Access Compliance Report Public Rights-of-Way (Curb Ramps)

Main Street: CRYSTALAIRE Cross Street: MORNING_TRAIL Location: W

ADA ID: RPRK211019174034 Ramp Type: Type 4 - Parallel Initial Pass/Fail: Fail Overall Compliance: No Severity Score: 45

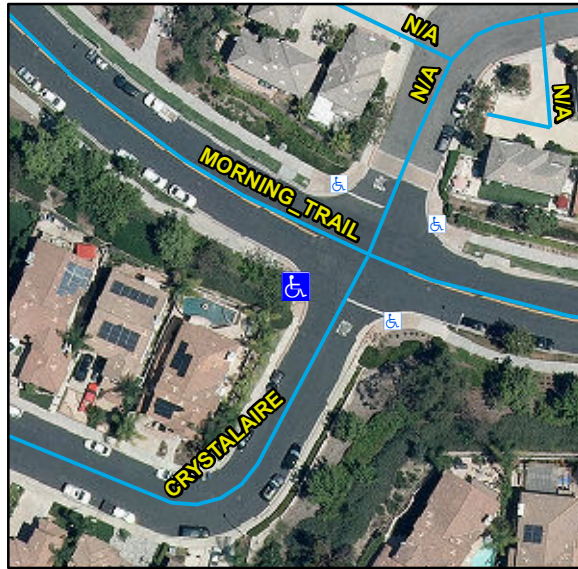
R204.3, R304.3.2, R304.5.3, STD 1115

Compliance	Description	Data	Compliance	Description	Data
N/A	Ramp Length LT (in)	113	N/A	Ramp Length RT (in)	114
Yes	Ramp Width LT (in)	55	Yes	Ramp Width RT (in)	54
No	Ramp Run Slope LT (%)	8.7	Yes	Ramp Run Slope RT (%)	7.2
No	Ramp Cross Slope LT (%)	11.3	No	Ramp Cross Slope RT (%)	9.7
N/A	Landing Present	N/A	N/A	DWS Provided	N/A
N/A	Landing Length (in)	N/A	N/A	DWS Contrast	N/A
N/A	Landing Width (in)	N/A	N/A	DWS Length (in)	N/A
N/A	Landing Run Slope (%)	N/A	N/A	DWS Full Width	N/A
N/A	Landing Cross Slope (%)	N/A		DWS Offset Type	N/A
N/A	Landing Movement Obstructed?	N/A	N/A	DWS Offset Left (in)	N/A
	Landing Movement Type	N/A	N/A	DWS Offset Right (in)	N/A
N/A	Landing Shared	N/A			
N/A	Clear Space	Yes			
N/A	Clear Space To Crosswalk (in)	N/A			
N/A	Marked Crosswalk 1	No	N/A	Marked Crosswalk 2	No
	Crossing 1 Direction	NE		Crossing 2 Direction	SE
	Marked Crosswalk 1 Width (in)	N/A		Marked Crosswalk 2 Width (in)	N/A

Remove & Replace Curb Ramp With Two New Directional Ramps or Equivalent.
